BUILDING COMPLETION REPORT

Undersigned begs to report that the construction of add: & all: to Bungalow
on plot No. 127, 1st-4 Sheet Janeshed Quarter owned by
Mr. Kewabram Chhappi
has been completed according to plans approved by the Municipal Corporation.
Orders are requested to file the correspondence.

Re. Plot No. 127 J.M.4 Jamshed Cr.

PROPOSED · ADDITIONS · & · ALTERATIONS · TO · BUNGALOW · ON · PLOT N^o 127 · J · M · A ·
JAMSHED · QUARTER ·
SCALE · 8 FT TO AN INCH ·
FINAL PLOT N^o 796

· GROUND · FLOOR ·

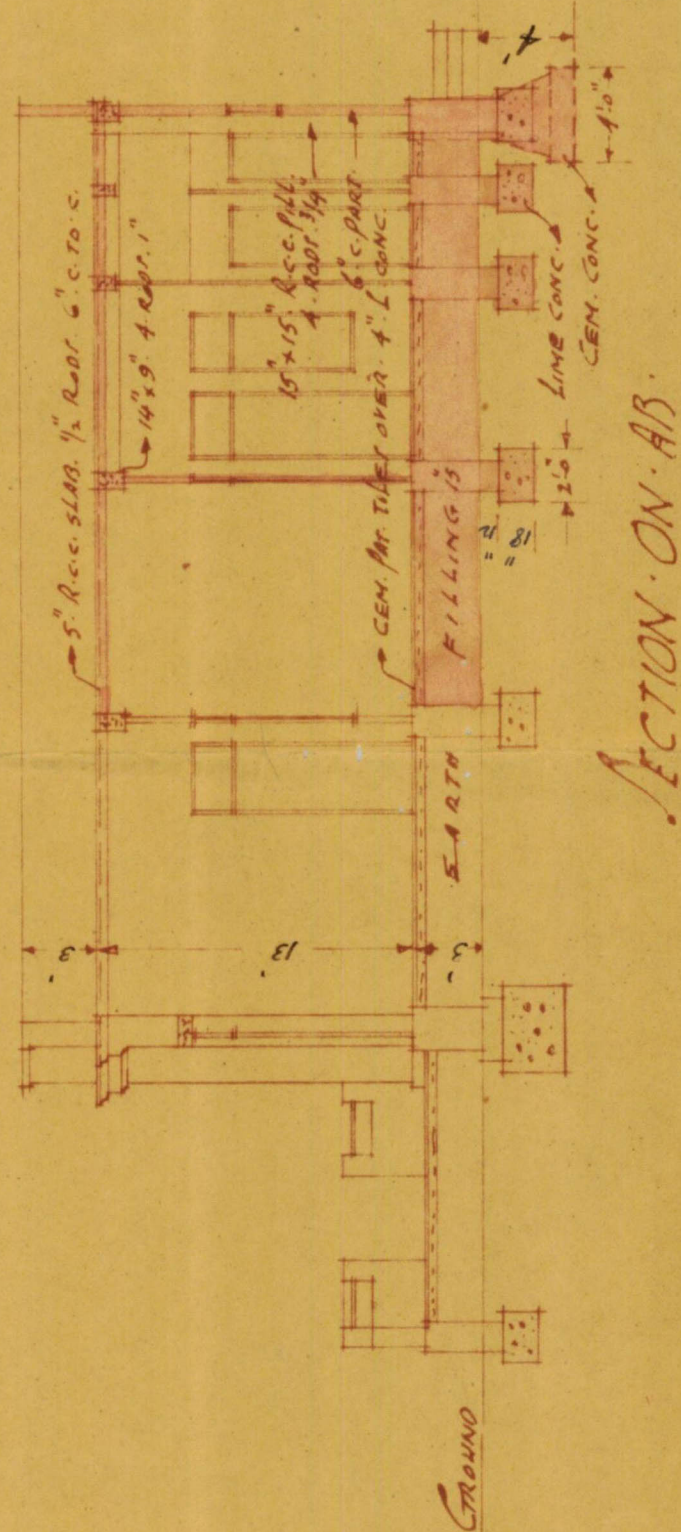
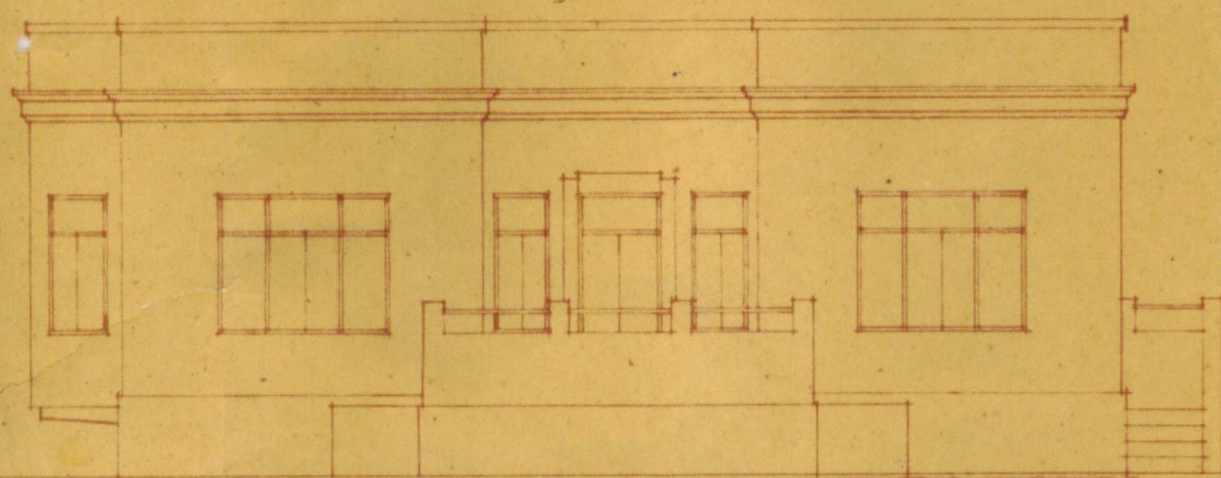
The allowable built-up area in the plot is 158.12 sq. yds.
The area actually built-up, inclusive of plaster is 160.18 sq. yds.
The owner & the architect state that the plaster should be
excluded as the building work was done previous to our
circular re. plaster being counted in built area was issued.
If the plaster is excluded, the area will be within the
allowable limit.

With reference to the completion certificate of the above plot, sent by you, I have to inform you that the built up area of the bungalow as constructed by you comes to 160.18 sq.yards. This exceeds the allowable limit to which you can build. You are therefore requested to remove the excess built up area atonce.

Built-up area as measured at
site comes to 160.18 sq. yds.
B/1.2.

Plaster not to be counted in built-up area as
this is an old construction.
